SOLENOID VALVE SUPPLEMENT ELECTRIC/AIR SHIFT SYSTEM

POWER-MISER KIT NO. 48M81251 Solenoid No. 35M2X749 Replaces Solenoid No. 35M00310 and 35M062E1. POWER-MISER VALVE PORTING DIAGRAM Note: Exhaust port requires Breather Part No. 44M30137 to be installed for added protection. SUPPLY OUT(CYL)

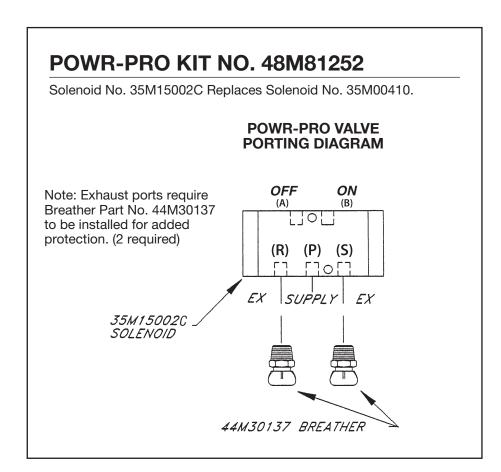
Note: This supplement to be used in conjunction with the original installation instructions. The new solenoid valve being used along with the addition of a breather in the exhaust port(s) is for added protection against contamination.

Slightly different fittings may be required to hookup air lines when solenoid is used as a field replacement.
